ADAPTABLE HOUSING ASSESSMENT REPORT

PROJECT:	142-146 Pitt Road North Curl Curl NSW 2099
STAGE:	Development Application Phase
REFERENCE:	23074.1-AS4299
DATE:	23 rd November 2023
CLIENT:	Balito 1 Pty Ltd

Figure 2.1 – Unit L0.4 Pre and Post adaptation layouts

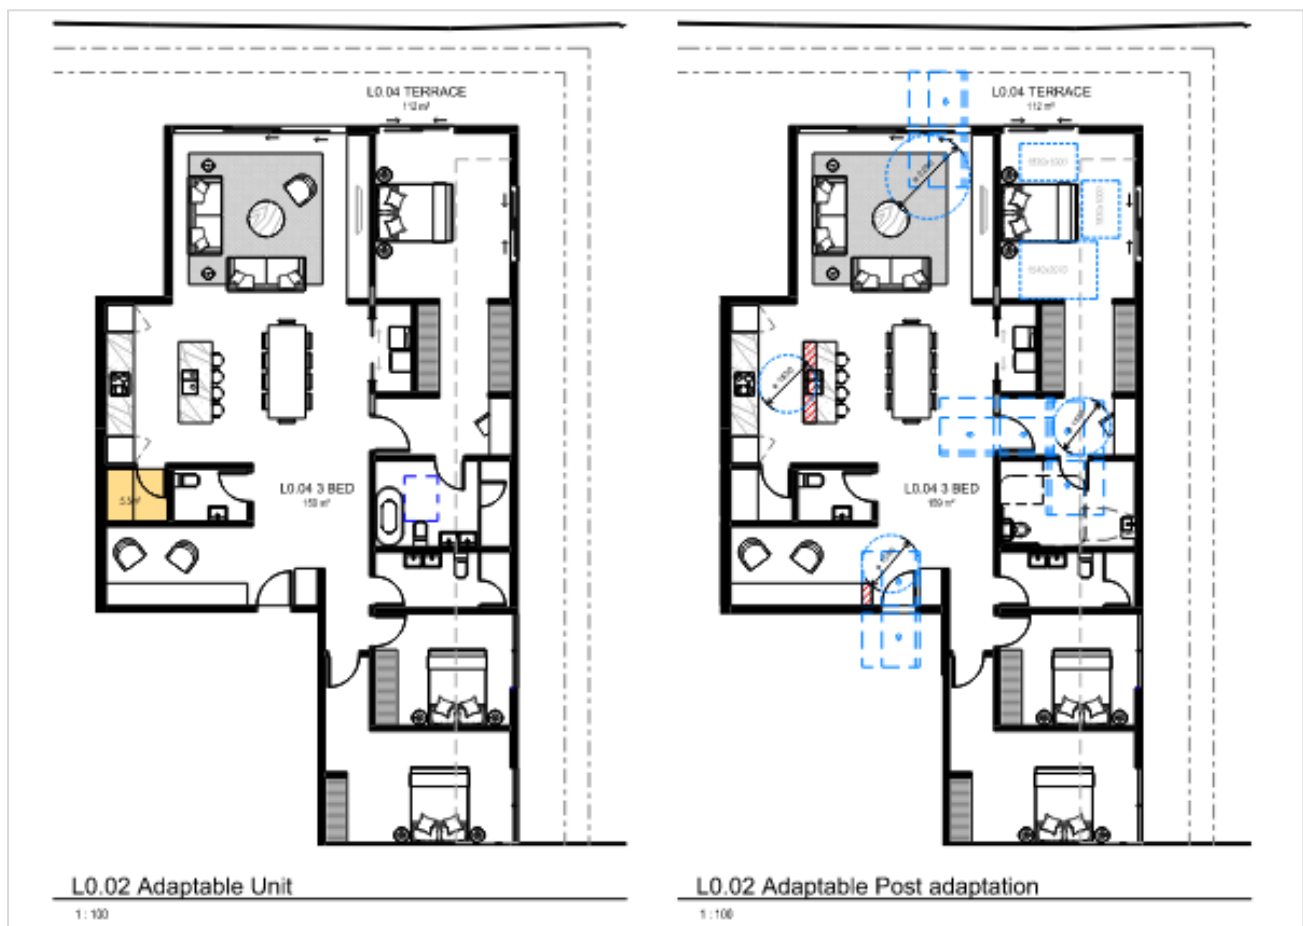
Clause No.	Requirement/s	Comment/s	Status
2.3	Drawings showing the housing unit in its pre-adaptation and post-adaptation stages shall be provided. A description of how the adaptation is to be achieved shall also be provided.	Drawings showing the housing unit in its pre-adaptation and post-adaptation stages have been provided. A description of how the adaptation is to be achieved shall also be provided (this includes provision of services, backing supports for grabrails, etc).	CRA

Figure 4.1 – Unit L0,04

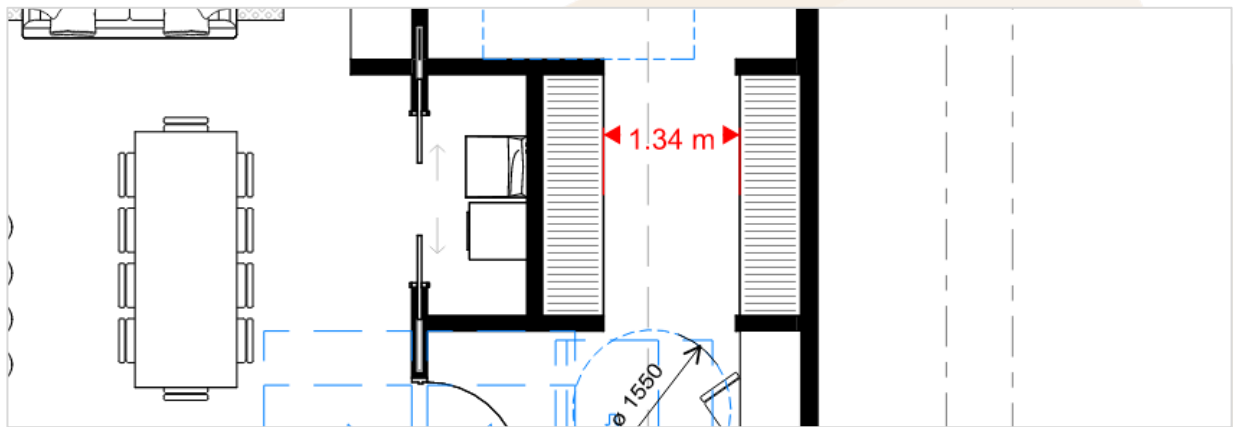
Clause No.	Requirement/s	Comment/s	Status
4.6.1	At least one bedroom shall be capable of accommodating a queen size bed (i.e., 1525 x 2030mm) and a wardrobe and the circulation space requirements of AS1428.2 clear of wardrobe fixtures.	<p>The following issue/s are identified in relation to the main bedrooms -</p> <ul style="list-style-type: none"> (a) A clearance of less than 1.2m at the foot of the bed within the bedroom of unit L2.10; and (b) Circulation space of less than 1,550mm in front of the wardrobes within both unit L0.04 and L2.10. <p>Notwithstanding the above, at least one bedroom within each adaptable unit is to be provided with adequate clearances to accommodate a queen size bed (i.e., 1525mm x 2030mm), wardrobe and circulation space requirements of AS1428.2, being -</p> <ul style="list-style-type: none"> (a) A clearance of not less than 1m each side of the queen size bed; (b) A clearance of not less than 1.2m at the foot of the bed; (c) A circulation space of min. 1,550mm in front of the wardrobe. 	DNC
